**LEVY NUCLEAR PLANT, UNITS 1 AND 2  
DOCKET NOS. 52-029 AND 52-030  
SUBMITTAL OF EXEMPTION REQUEST AND DESIGN CHANGE DESCRIPTION FOR  
DEPARTURE FROM AP1000 DCD REVISION 19 TO ADDRESS COMPLIANCE WITH  
IEEE 603-1991**

Request For Exemption Regarding  
IEEE 603-1991 Compliance

**Tier 2 Licensing Basis Documents -**  
**Proposed Changes**  
**(19 pages including cover page)**

**Design Change to Address Compliance with  
IEEE 603-1991 for Source Range Neutron Flux Doubling**

Figure 7.2-1 (Sheet 3 of 21)

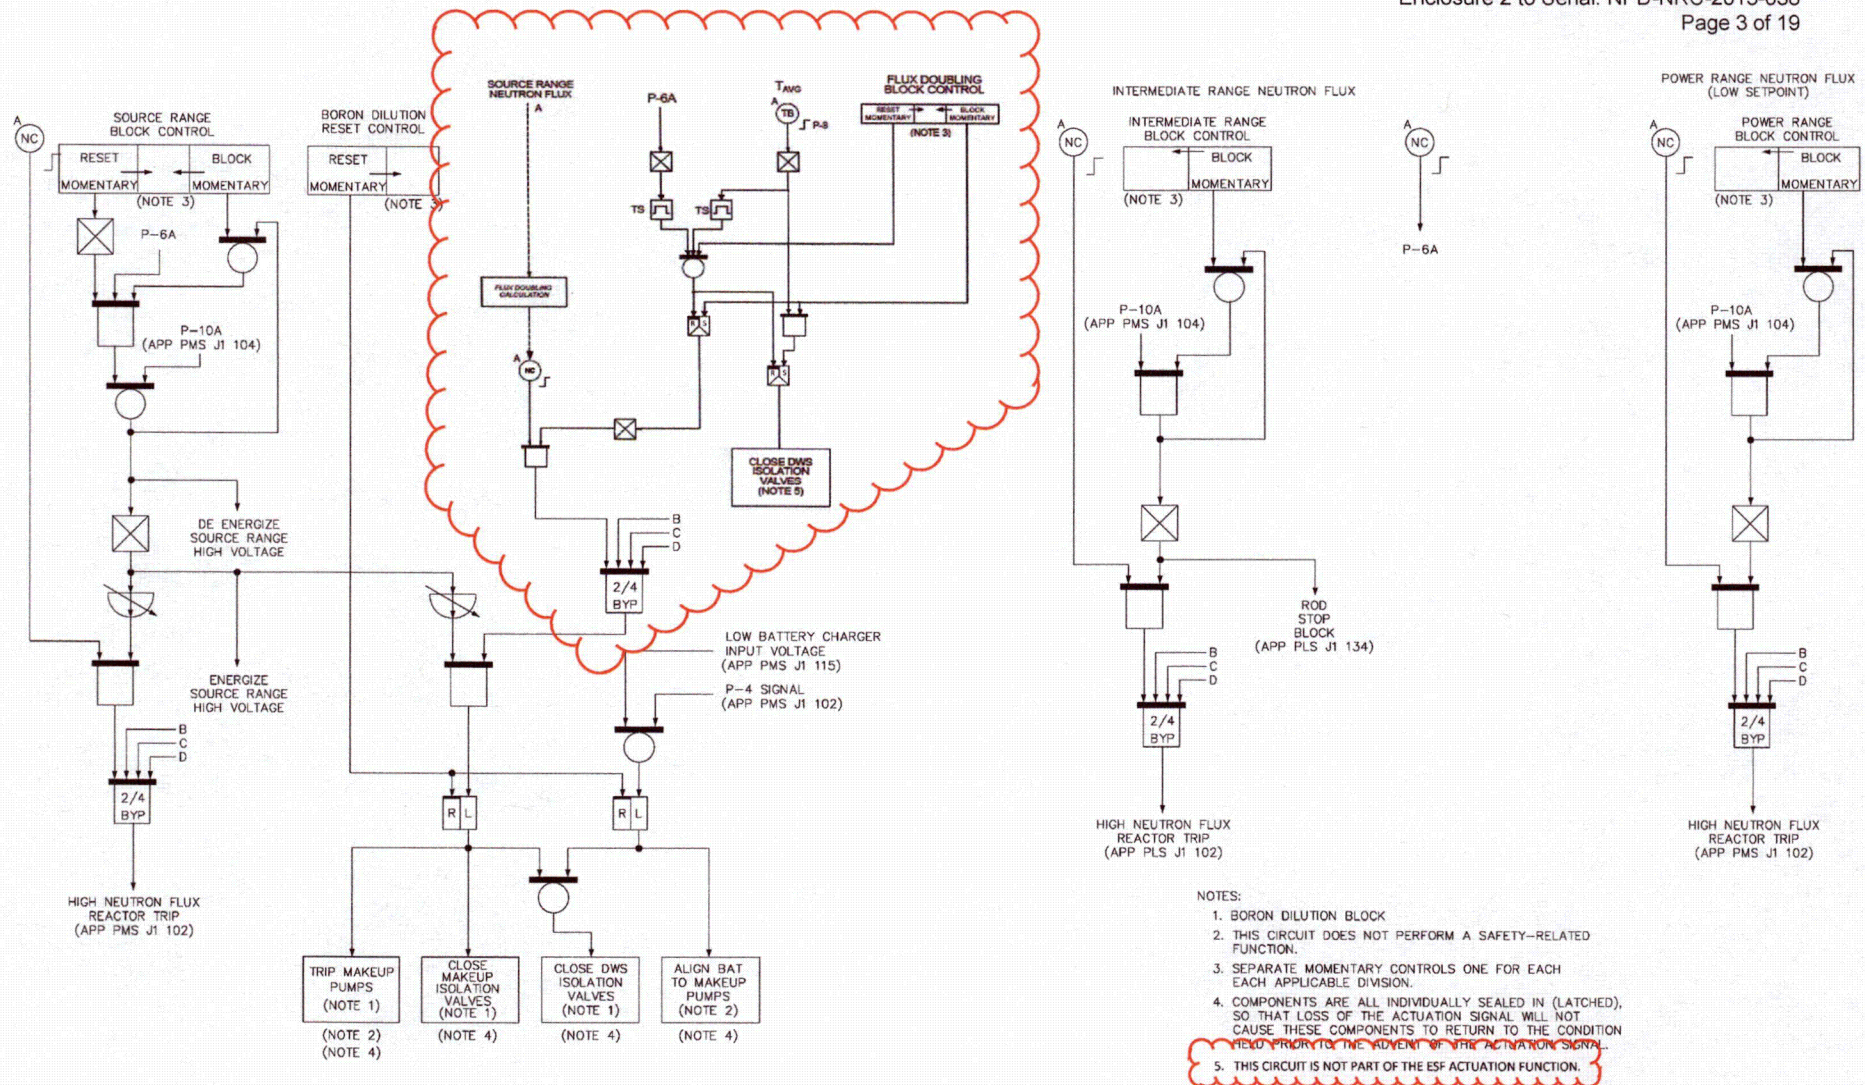
Operating bypasses are included in the AP1000 design to allow functions to be blocked so normal plant operations can occur without unnecessary actuation of safety systems. All of the protective actions initiated by the Protection and Safety Monitoring System (PMS) comply with the criteria of IEEE 603 Clause 6.6 with the exception of the PMS arrangements for blocking the source range neutron flux doubling logic input to Boron Dilution Block shown on DCD Figure 7.2-1 (Sheet 3 of 21).

- Figure 7.2-1 (Sheet 3 of 21); Add logic for condition when source range flux doubling signal may be manually blocked and automatically reset.
- Section 7.3.1.2.14, Boron Dilution Block; Revise discussion of conditions when the source range flux doubling signal may be manually blocked and when it is reinstated.

- 1) Add a new permissive, P-8, to permit blocking the flux doubling logic during reactor startup. (P-8 provides the logical permissive input to the PMS. P-8 is set to 551°F Reactor Coolant System (RCS) temperature, the minimum temperature for criticality.)

- 2) Add logic that will cause the PMS to force CVS valves 136A and 136B closed if the flux doubling logic is blocked when reactor temperature is less than P-8. (This ensures a permissible condition exists before flux doubling is bypassed below P-8, which is one option from IEEE 603 - 1991, the other being to perform the appropriate safety functions.)

- 3) When RCS temperature is below P-8, reset the flux doubling logic if CVS valves 136A and 136B are opened.
- 4) Add an additional reset of source range flux doubling logic when RCS temperature falls below P-8. Existing PMS design resets flux doubling logic when neutron flux decreases below P-6.

Figure 7.2-201 (Sheet 3 of 21)

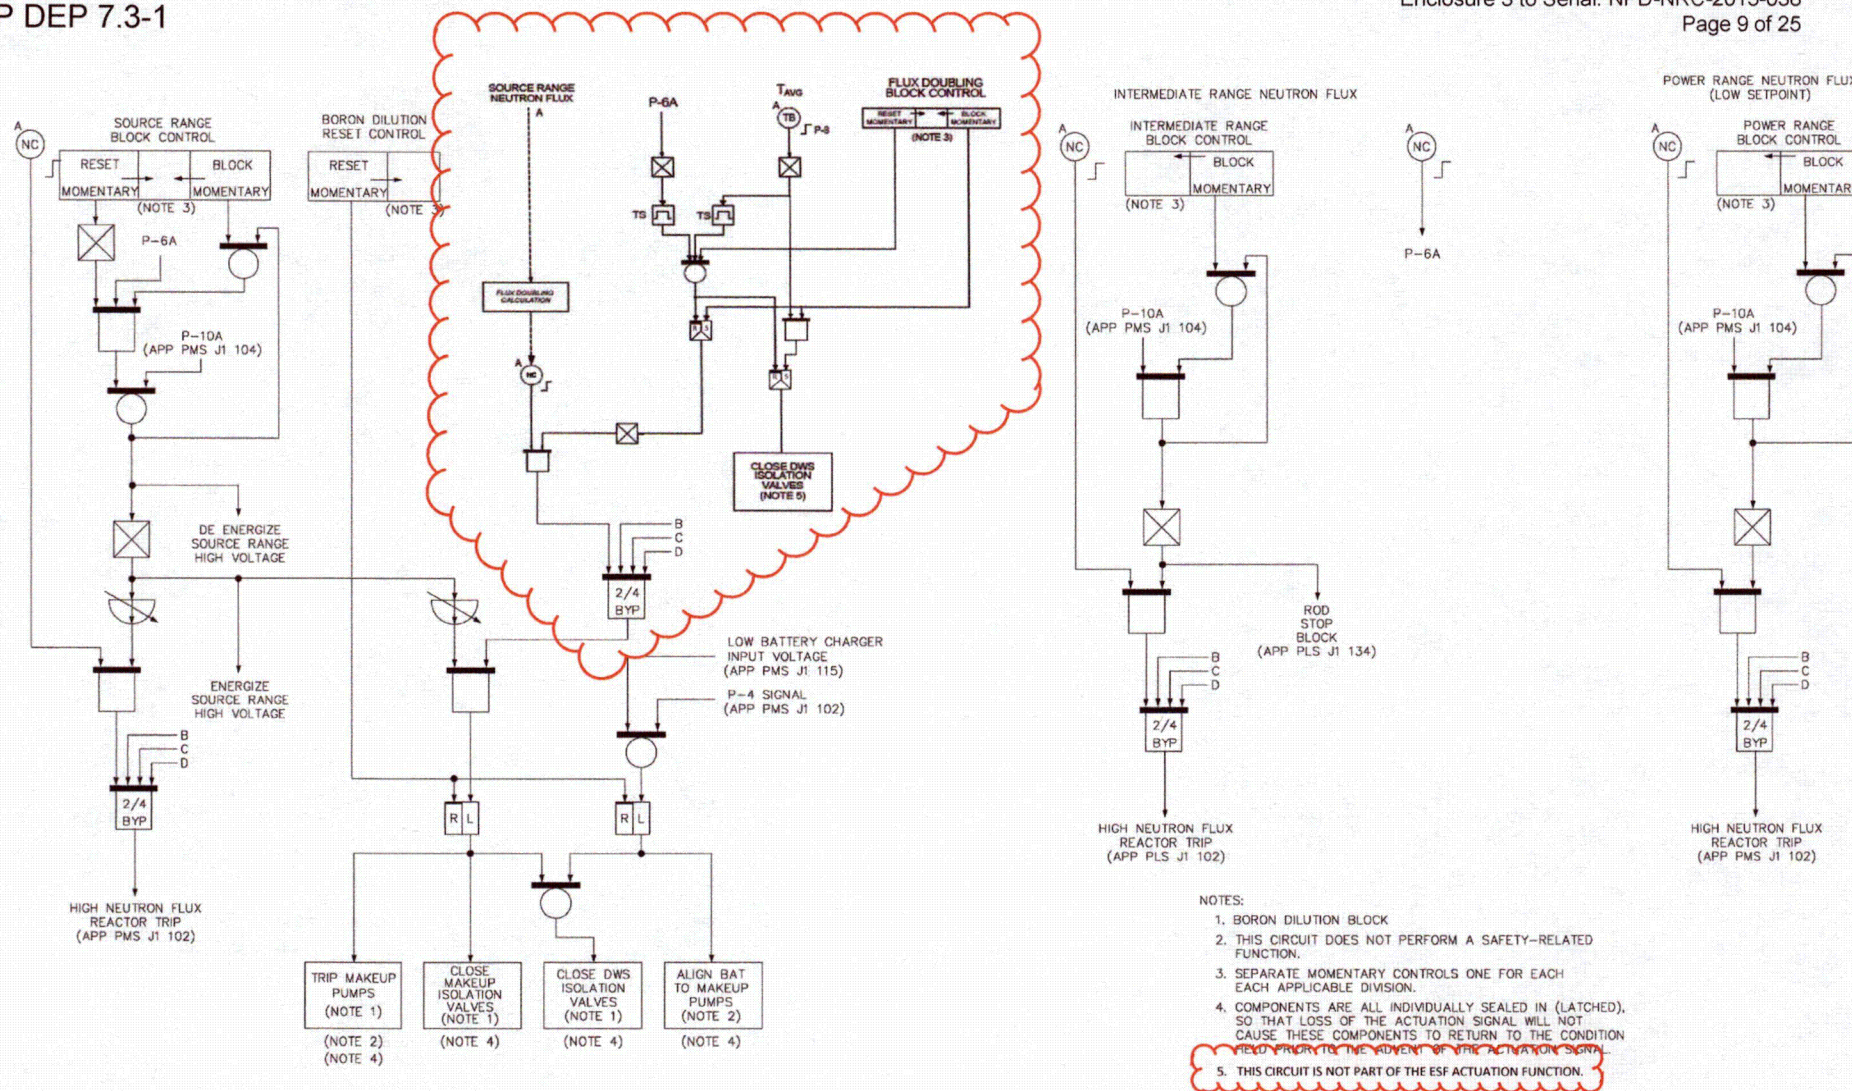
1. COLA Part 2, Figure 7.2-201 will be revised to show the P-8 permissive to allow blocking of Flux Doubling function
2. COLA Part 2, Subsection 7.3.1.2.14 will be revised to state "This source range flux doubling signal may be manually blocked to permit plant startup and normal power operation when reactor coolant average temperature is above the P-8 setpoint. It is automatically reinstated when reactor power is decreased below the P-6 power level during shutdown or reactor coolant average temperature decreases below the P-8 setpoint. The Flux Doubling function can also be manually blocked during shutdown conditions when
